RE: New York SMSA Limited Partnership d/b/a Verizon Wireless Special Permit and Site Plan Application to Install a Public Utility Personal Wireless Facility at the Property Known as 52 Montrose Station Road, Town of Cortlandt, NY

Specifically, the redesigned Facility and the documents submitted herewith respond to the comments raised by the Town Engineer and Town RF Consultant as follows:

Response to the Comments from Town Engineer:

EXHIBIT A

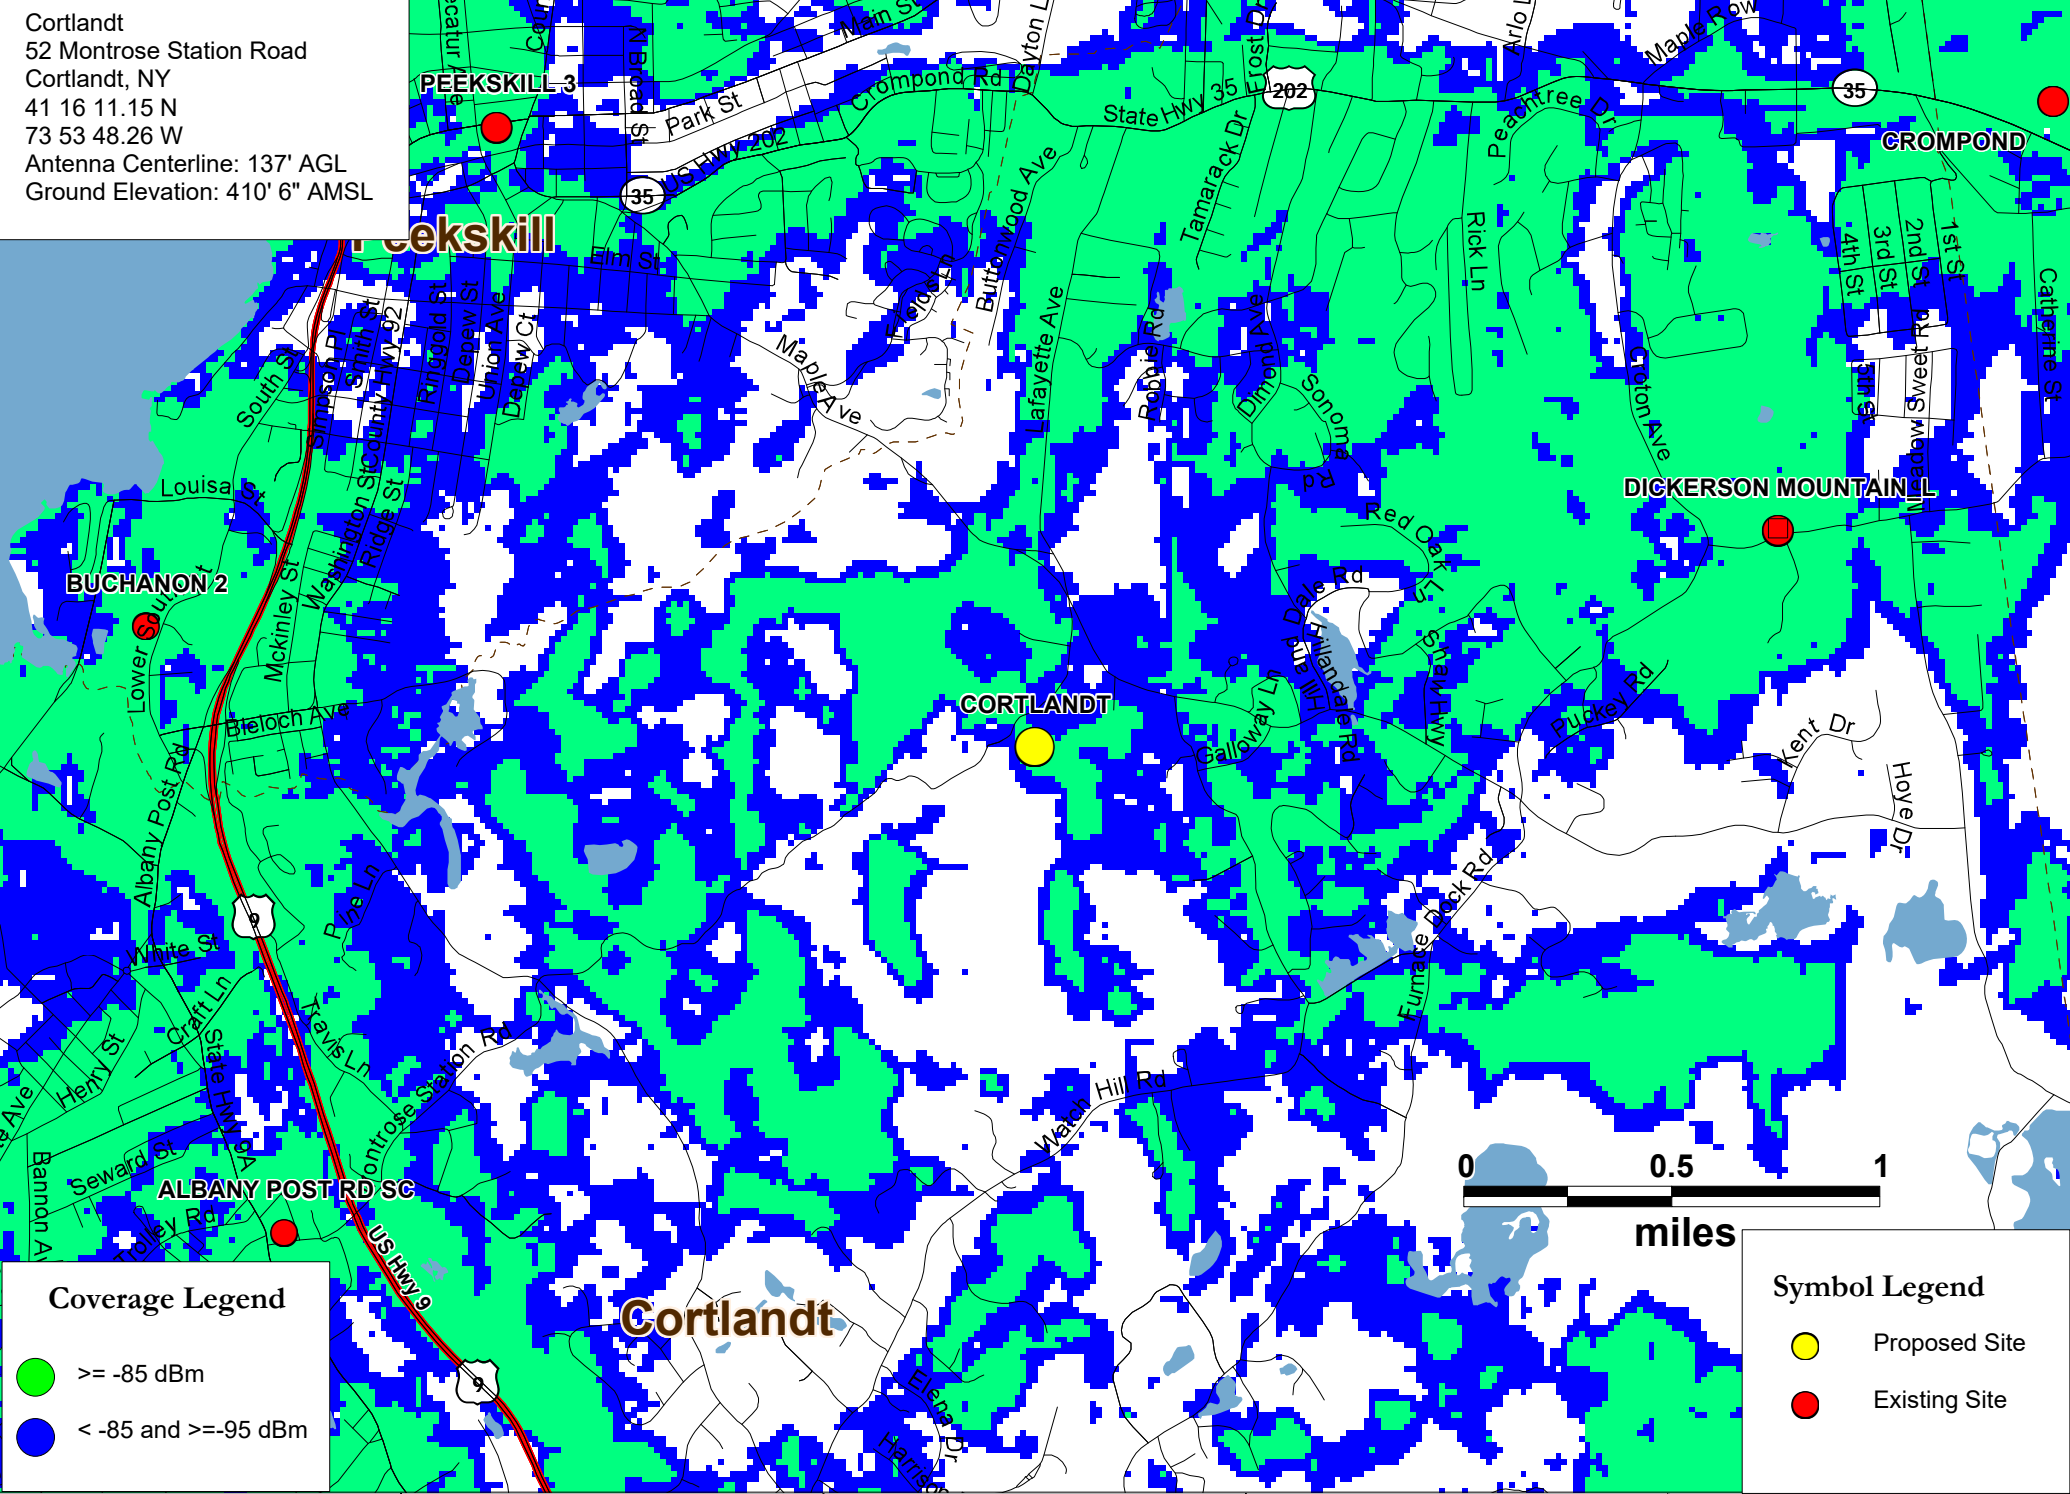
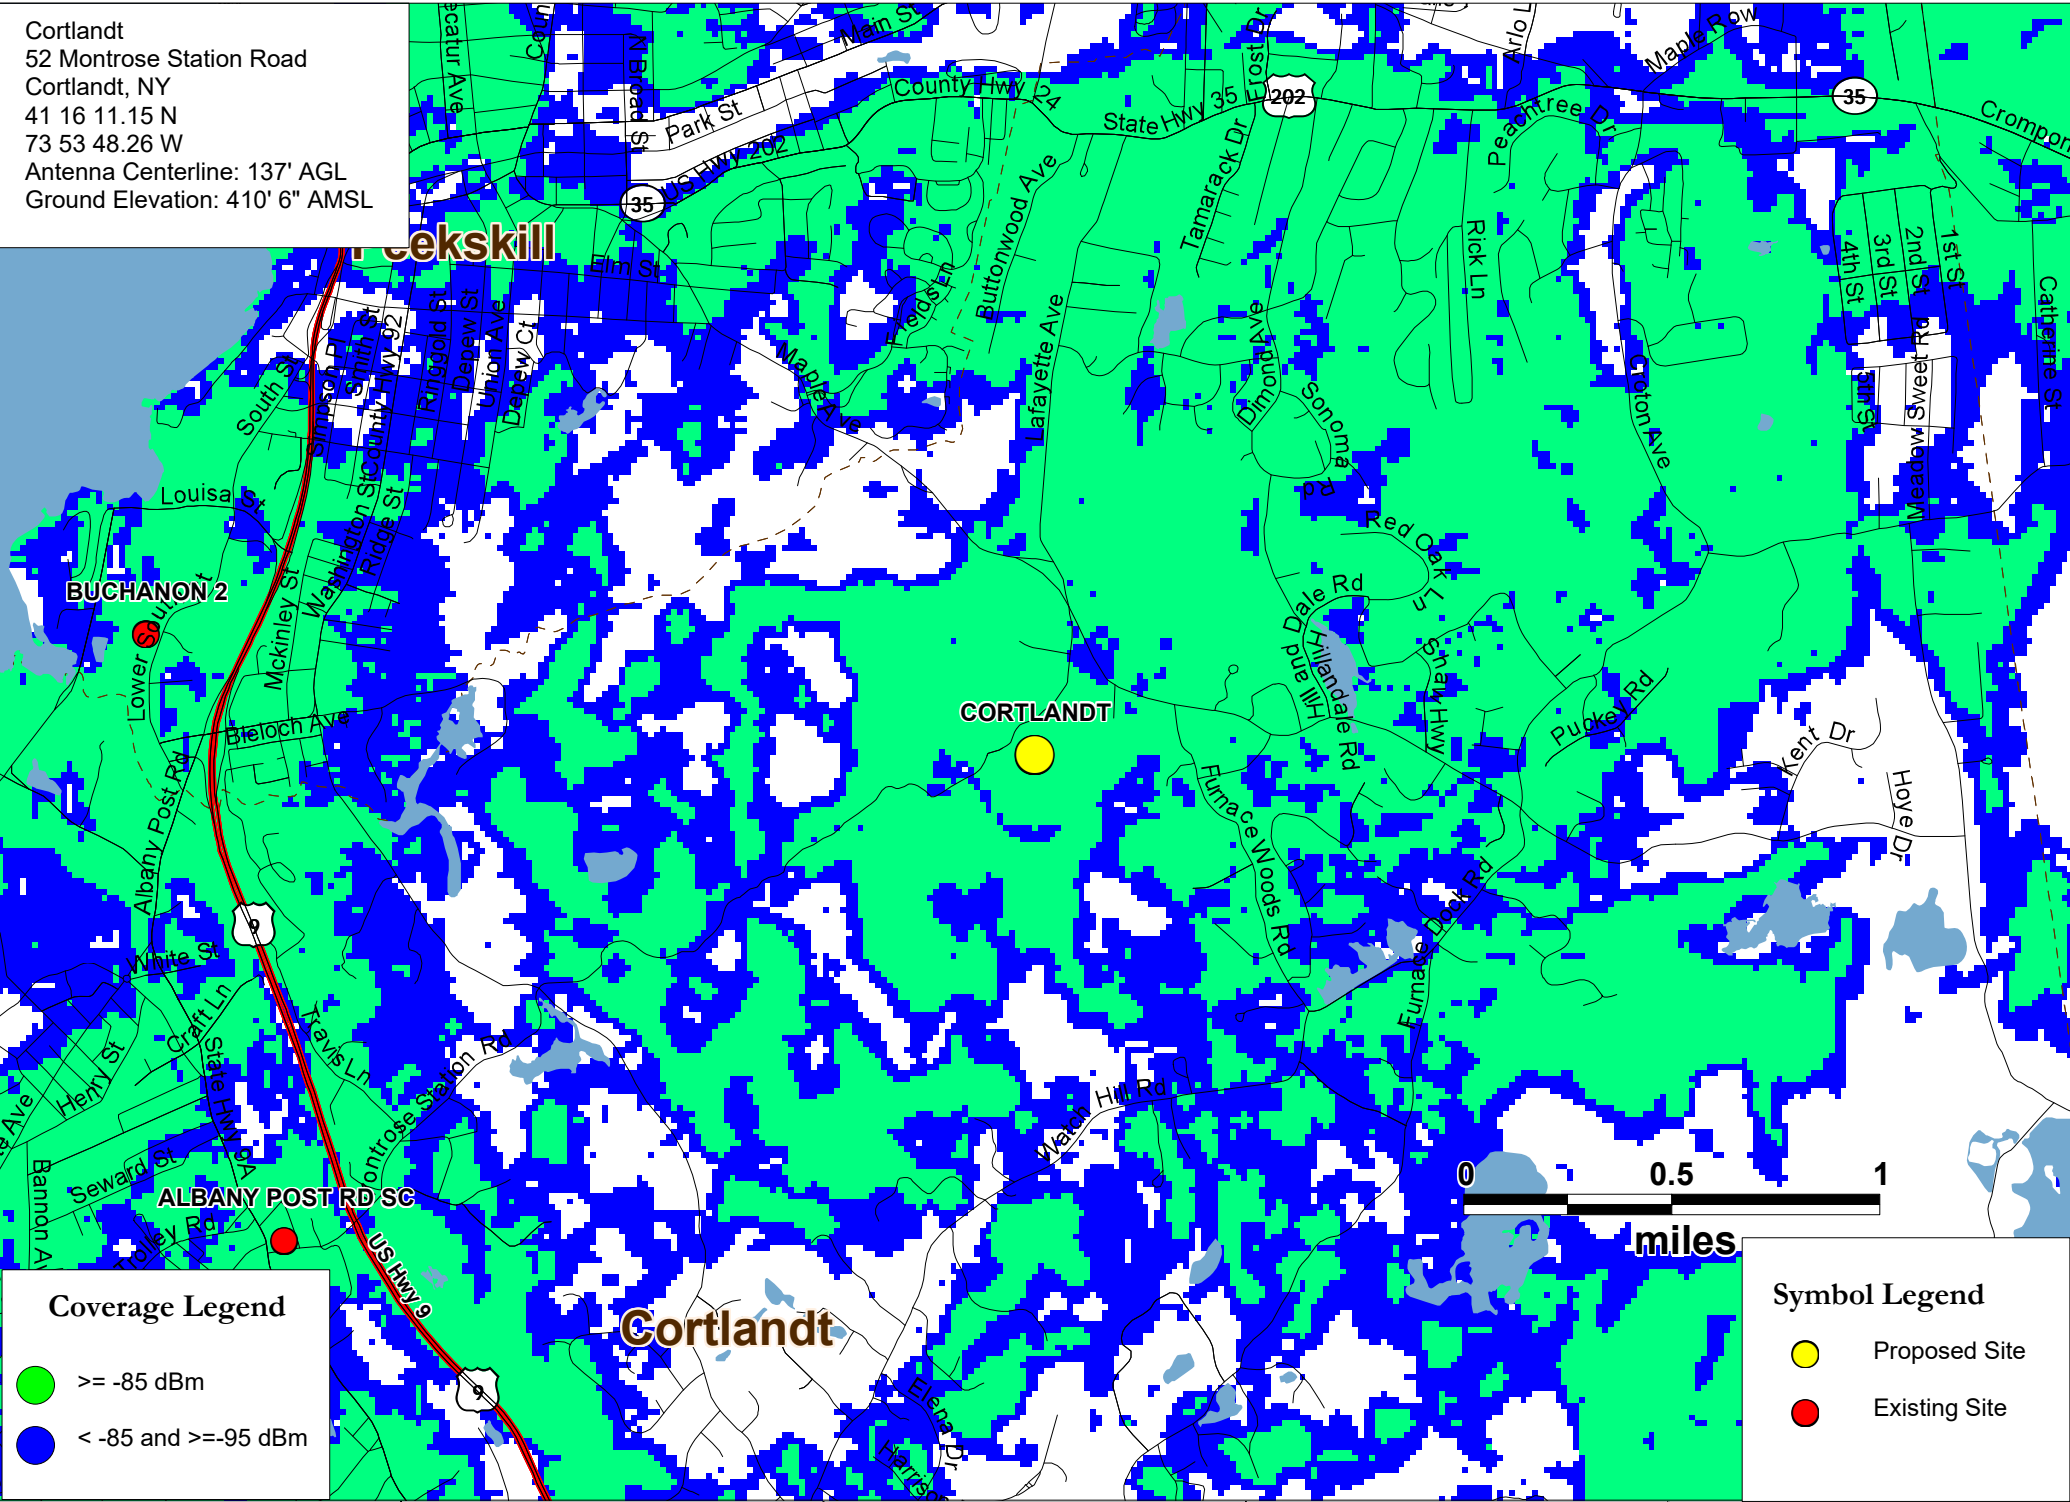
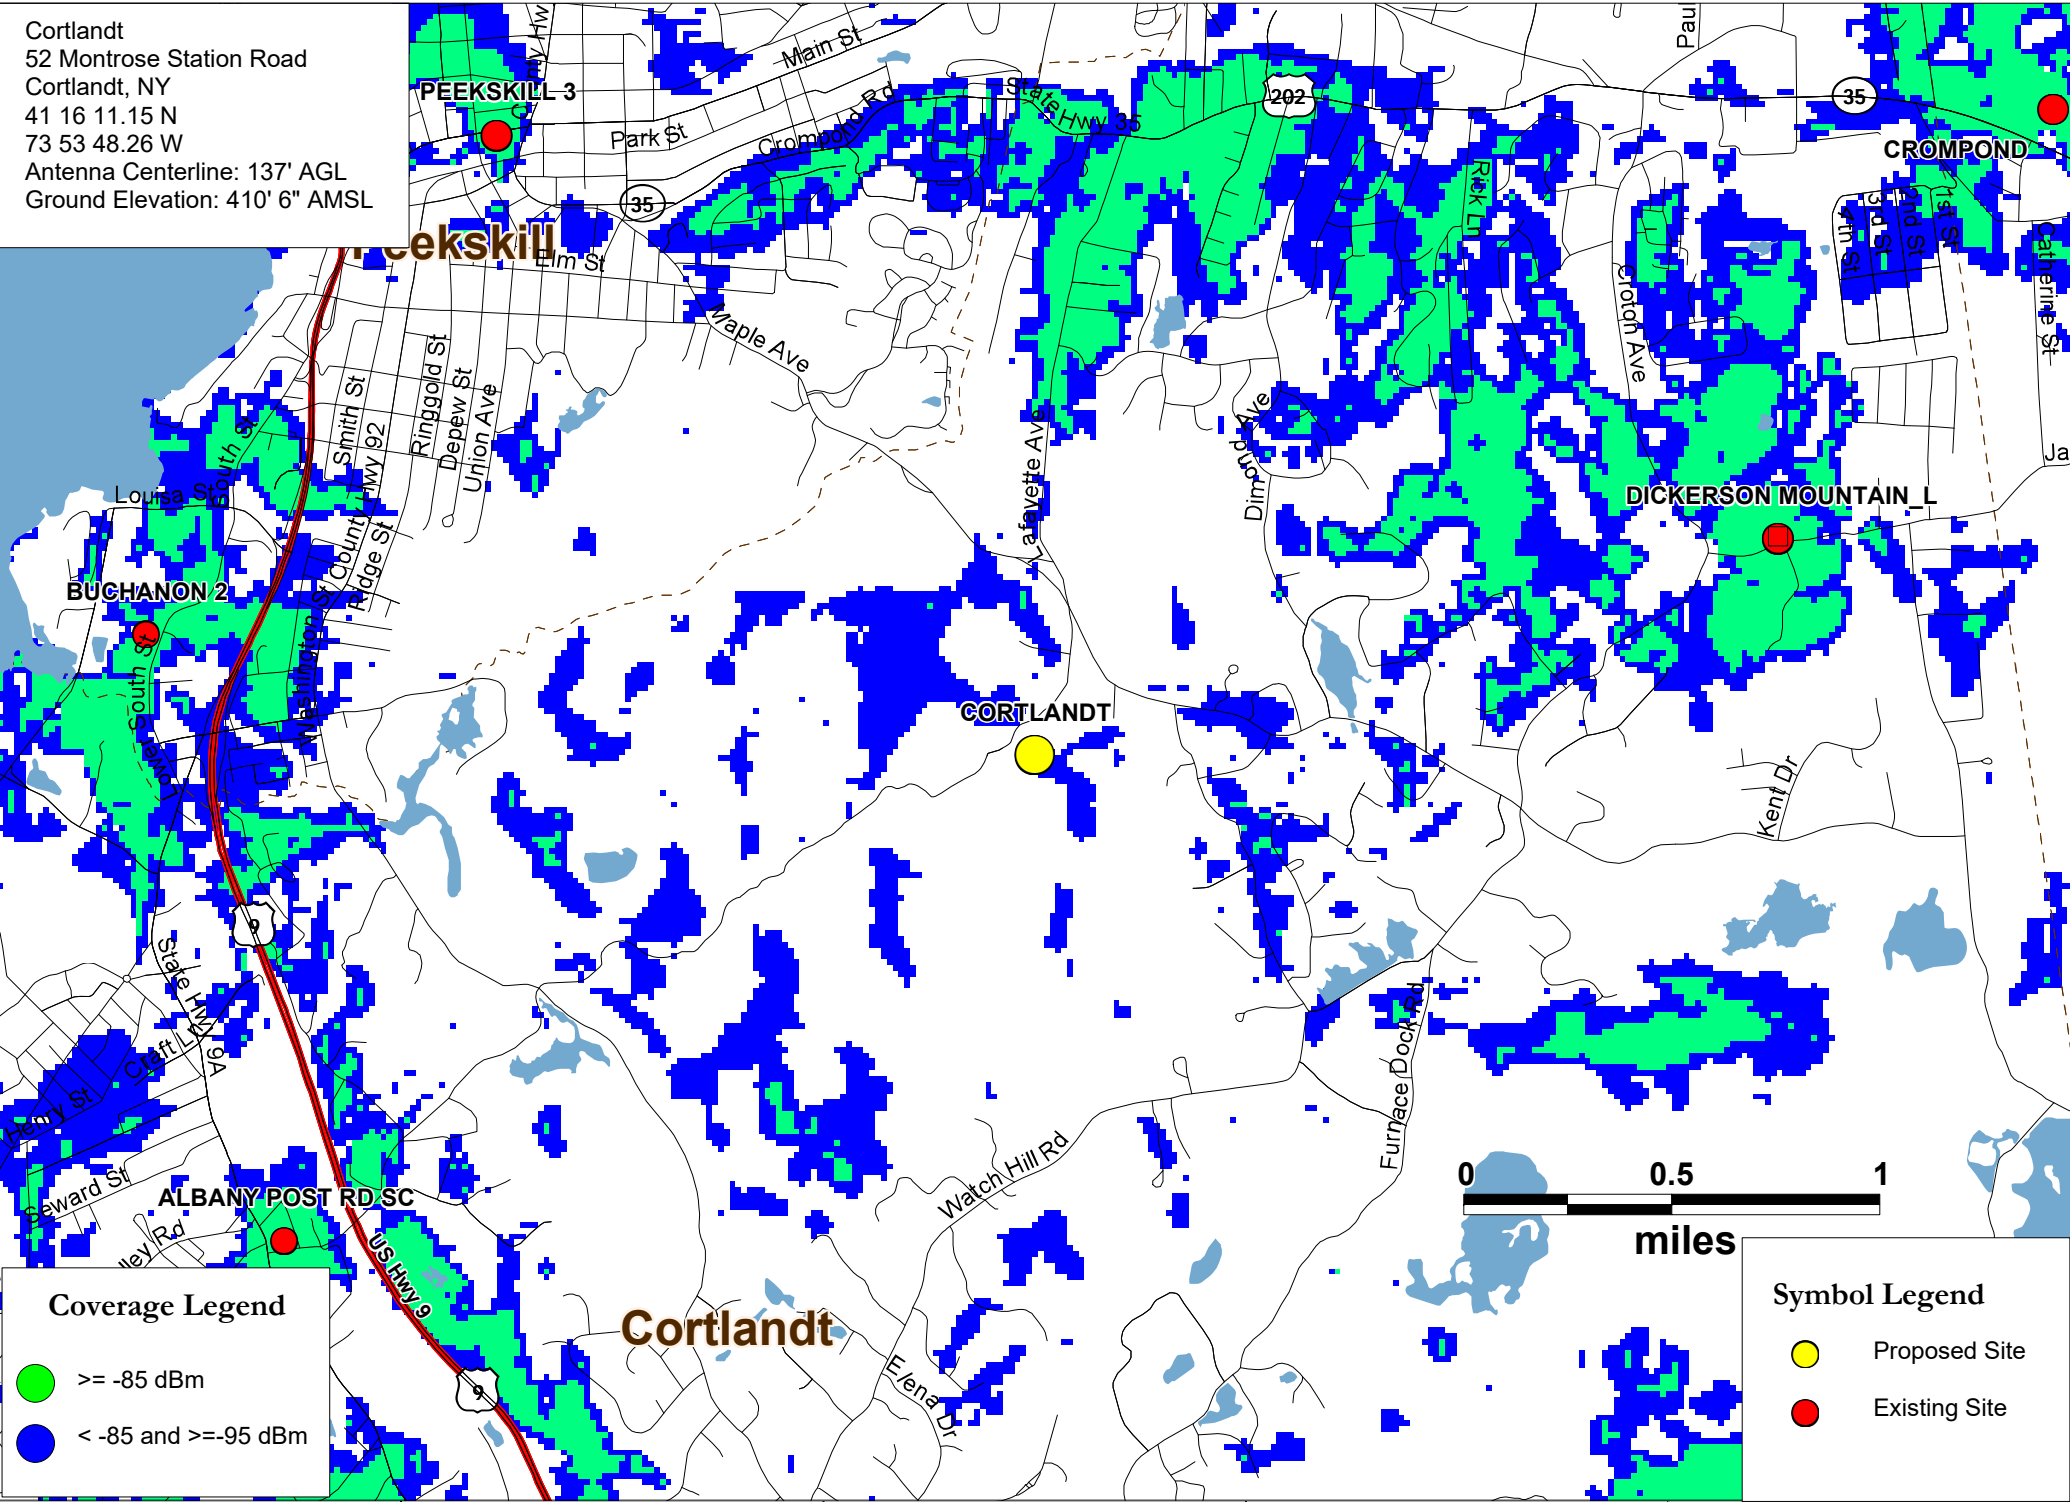
Town Consultant Comment: *The applicant has submitted supplemental material that contains a Supplemental Report (C Squared Systems, LLC, dated 8/16/19, signed by Martin Lavin) and signal propagation maps to demonstrate Verizon Wireless service at the proposed location. The supplement report and maps provided show only 750 MHz service and show required signal strength for reliable in- building and in-vehicle service for 750 MHz frequencies at -85 dBm and -95 dBm, respectively. As noted above and as discussed on the conference call, we recommend that Verizon submit separate propagation maps for all frequencies that it is authorized to operate in this area, showing all existing and proposed coverage from all adjacent sites. Drive test data should also be provided to confirm service deficiency. To confirm the accuracy of the data and maps provided, we require the applicant to complete the attached Propagation Data Study Sheet and attest to the maximum power being utilized for the maps. INCOMPLETE.*

Response: Attached hereto as Exhibit A are revised maps showing the proposed coverage from the Site at its new proposed location in the 750 MHz frequency band, which provides the most geographic area, and the 2100 MHz frequency band, which provides the least geographic coverage area. Therefore, with both of these bands in the C Squared February

Report, the best and worst scenarios were presented. As the need for coverage in the 750 MHz range has been established, there is no need to show the coverage area from the higher frequencies (i.e 850, 1900 MHz), which would be smaller geographically and fully encompassed in the proposed 750 MHz coverage.
